MONTGOMERY COUNTY PLANNING DEPARTMENT
 THE MARYLAND-NATIONAL CAPITAL PARK AND PLANNING COMMISSION
Item #
MCPB 6-14-07

MEMORANDUM

REVIEW TYPE: **Site Plan Review**
 CASE #: **820050150**
 PROJECT NAME: **Cabin Branch Infrastructure Plan**
 APPLYING FOR: Approval of an Infrastructure and Roads Only Site Plan to accommodate a maximum of 1,886¹ residential dwelling units, 500 senior units and 2,436,000 square feet of retail and employment, including 635 TDRs and 236 MPDUs on 535.04 acres
 REVIEW BASIS: Div. 59-D-3 of Montgomery County Zoning Ordinance Section 19-64 for Final Water Quality Plan
 ZONE: MXPD, RMX-1/TDR
 LOCATION: Northwestern quadrant of the intersection of Interstate 270 and West Old Baltimore Road
 MASTER PLAN: Clarksburg Master Plan
 APPLICANT: FFTM 1, Limited Partnership, Winchester Homes, Inc., King Farm Partnership, Concordia Group and Adventist Healthcare, Inc.
 FILING DATE: November 4, 2004
 HEARING DATE: June 14, 2007

Revised Park Plan Exhibit

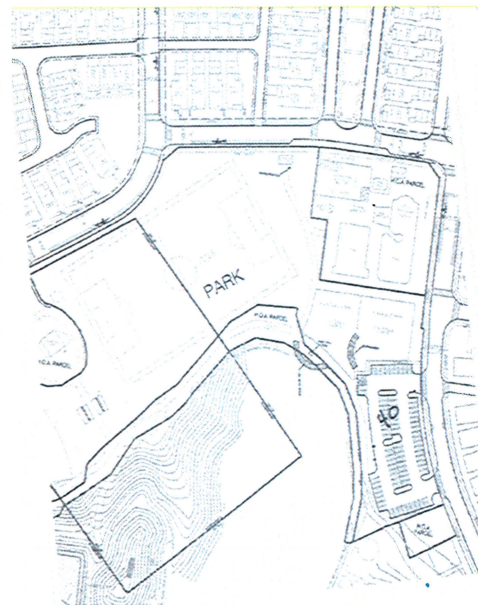
The approved Preliminary Plan parkland and park layout has proved to be problematic in a number of ways that is unacceptable to M-NCPPC park staff. These problems included the increased size of the proposed HOA pool/recreation center, which rendered the remaining usable park space inadequate for the proper layout and spacing of park facilities. The proposal also had insufficient parking spaces for the facilities, and the relationship of the spaces to the facilities. Other issues included the proposed grading, retaining walls and fencing that made the softball field space and soccer field too restricted and created unsafe conditions. Staff was concerned about the future maintenance of the walls by the HOA and the location of trails connecting the park facilities. The close proximity of fields, trails and other park facilities to one another and to adjacent roads and retaining walls forces the park design to need an excessive number of fences

The softball field, which is the least needed of the park amenities, will be eliminated from this park area to allow more open play area and provide a more natural and aesthetic setting for the front of the historic house. This will also prevent possible user conflicts such as balls landing on cars or visitors at the historic house area or on adjacent trails. One of the fences along the field's original foul line can therefore be eliminated and the land can perhaps be graded to reduce the size of the retaining walls along the parkland.

The proposed park is a deviation just with respect to the elimination of the ball field from the approved conditions of approval from the preliminary plan; however, the changes are consistent with the intent and purpose of a local park for this community.

- a. Provide a Local Park site to include the facilities as described in condition 8 below.
- b. Remove the community facility (pool/clubhouse) from the future Park site and relocate the facility to a more centralized location convenient to the residents and overall community. The location of the pool/clubhouse shall be identified with the first residential detailed site plan.
- c. Provide the community-wide open space and a trail system as part of the minimum recreational concept for the overall Cabin Branch development. The exact locations, dimensions and sizes of these facilities will be determined with the corresponding site plan.

- b. Within the dedicated local park acreage, Applicant to provide, at Applicants expense, the park's most needed active recreational facilities and amenities to include at least one (1) adult sized soccer field, multi-age playgrounds acceptable to M-NCPPC staff, a picnic area with 2 shelters, 8' minimum width hard surface trails within the park to serve the various facilities (10' wide where needed for maintenance access), a drinking fountain, park signage and information kiosks, portable restroom pad and enclosure, appropriate fencing for safety purposes along the retaining wall (acceptable to M-NCPPC staff), park landscaping, and local park parking for at least 120 cars, including at least 60 spaces on the dedicated parkland. Parallel parking spaces along the park side of the adjacent roads should be appropriately striped and marked to delineate the individual parking spaces available for park users. Park dedication and facility layout to be substantially as set forth on the attached Park Site Exhibit, with final details of park design, engineering, grading and layout to be determined in coordination with, and acceptable to, M-NCPPC park staff prior to certified site plan approval. Facilities to be constructed to park standards and specifications after procurement by Applicant of appropriate park permit. Copies of applicable standards and specifications will be provided to Applicant by time of certified site plan approval.

- c. No retaining walls or stormwater management ponds or facilities to be located on dedicated parkland.
- d. Applicant to construct hard surface and natural surface trails on dedicated parkland and throughout the community to connect open spaces, the elementary school and parkland together in an accessible, pedestrian friendly manner. Applicant to work with M-NCPPC staff prior to certified site plan approval to establish exact locations of needed trails in order to provide recreational opportunities for the communities and businesses within the subdivision. Trails within parkland to be constructed to park standards and specifications.

Overall plan of the stormwater management structures within the right-of-way

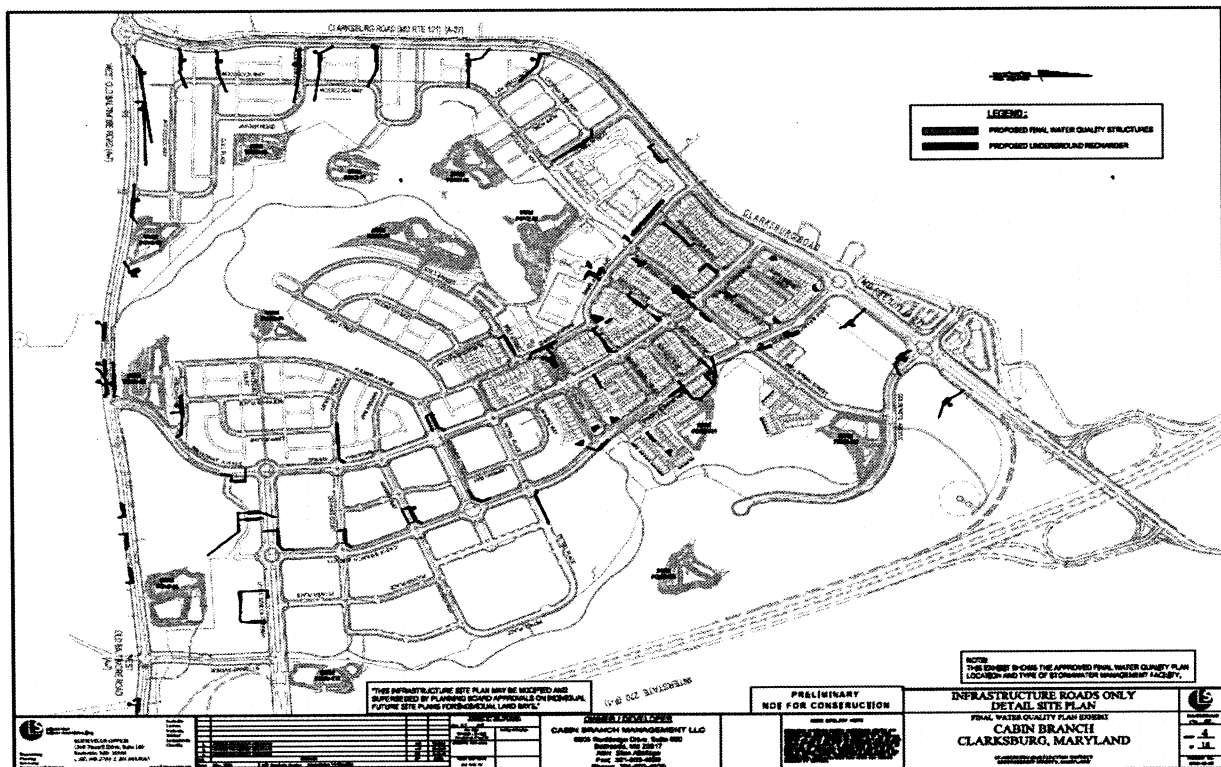
The agencies needed to understand and coordinate linkages between water quality structures, maintenance and streetscape elements; identify guidelines for locating water quality structures in a manner that accommodates access for maintenance and the provision of streetscape and achieves overall compatibility within a residential setting; and review proposed plans and identify any conflicts for access and streetscape.

There was a general discussion of DPWT’s approval of such structures in the ROW and their maintenance/access needs. Park and Planning staff asked questions about the specific characteristics of the structures and explored the question of how to plant trees in the vicinity of these elements. Both street trees and water quality structures have to be coordinated in a manner that works for both elements.

The Applicant pursued the viability of structures within the right-of-way to alleviate impervious coverage, visibility of unappealing structures, ease of maintenance and provide best management practices within a Special Protection Area. The Applicant has coordinated with many county and state agencies, as well as M-NCPPC, to collaborate on the functional aspects of the proposed facilities as well as the integration of those facilities with streetscape elements.

Guidelines for water quality structures within the ROW:

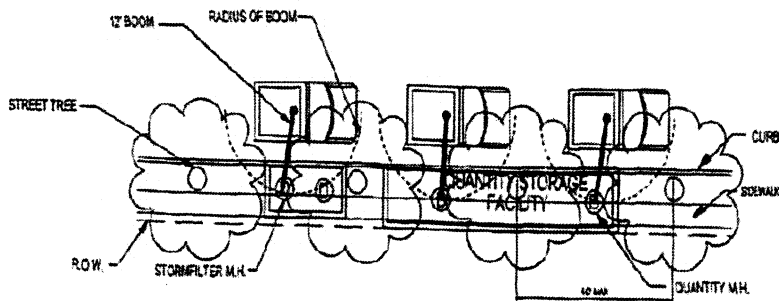
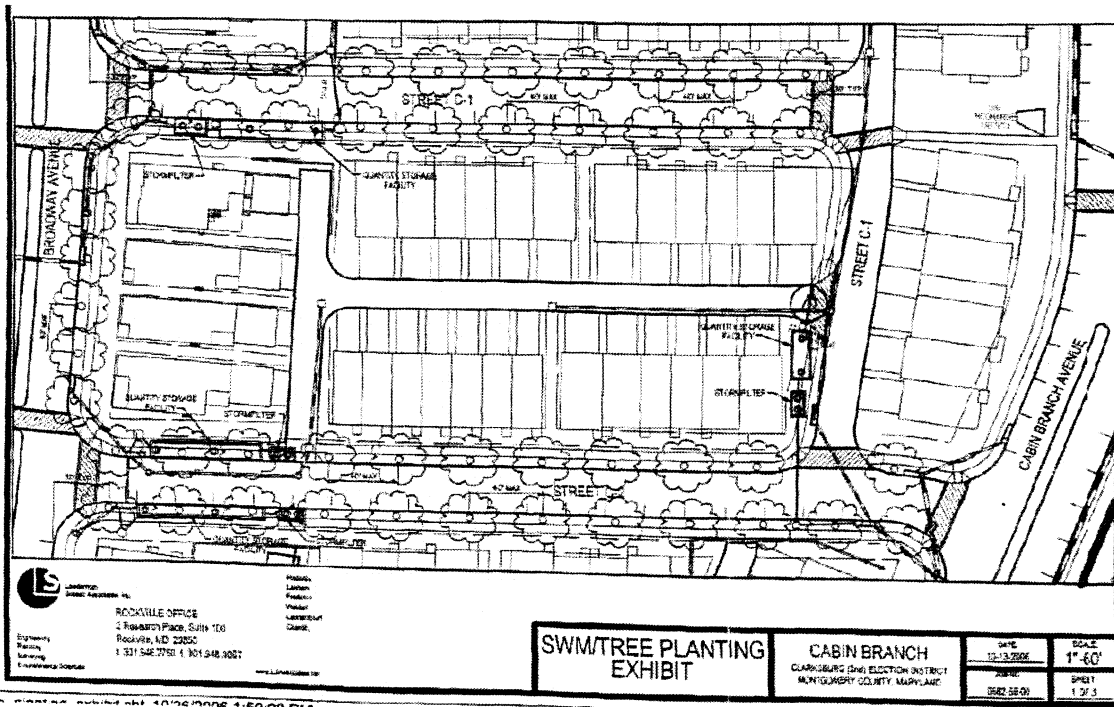
DEP explained the maintenance and access needs for the structures. Trucks need to pull up to the curbside adjacent to the structures and have at least 12 feet clear on either side to enable movement of the boom with the vacuum pipe that will remove accumulated pollutants and lift up the filter for media replacement. The underground detention pipe area, the larger rectangular area shown on plans, needs truck access also but only at the ends of the pipes, not in the middle unless the pipes exceed 100'-150' in length. DPS expressed the need to be sure that other elements such as the street lighting and fire hydrants also fit within the curbside.

DEP reaffirmed the intra-agency agreement to maintain SWM function within parklands. The group agreed upon the following parameters or guidelines and it was felt that the applicant would need to resubmit landscape plans that adhere to these parameters:

Park and Planning expressed a need to achieve a streetscape treatment with trees planted approximately 30 to 40 feet on center given the high density and townscape character of the proposal. In fact, the achievement of a townscape character is why the applicant proposes the water quality structures for the project. The proposed plan is striving for a townscape character within a residential area of the plan. The Applicant also addresses the visual and aesthetic characteristics by providing a consistent streetscape.

Park and Planning also expressed a need to be able to plant grass between the curb and sidewalk area to emphasize the residential character.

- 1) Water quality structures must be within the right-of-way or in an outlot. They cannot be placed on private property or in the PUE.
- 2) Such structures must not be located adjacent to the fronts of residential lots due to compatibility concerns.

- 4) Trees may be planted along the curbside but longitudinally located to ensure access to the structure and to the pipe area. In general, an area 12 ft. to either side of the structure access points must be clear of trees and at the end of the pipe areas. The best location for a street tree, therefore, would be in the longitudinal middle of the pipe area.
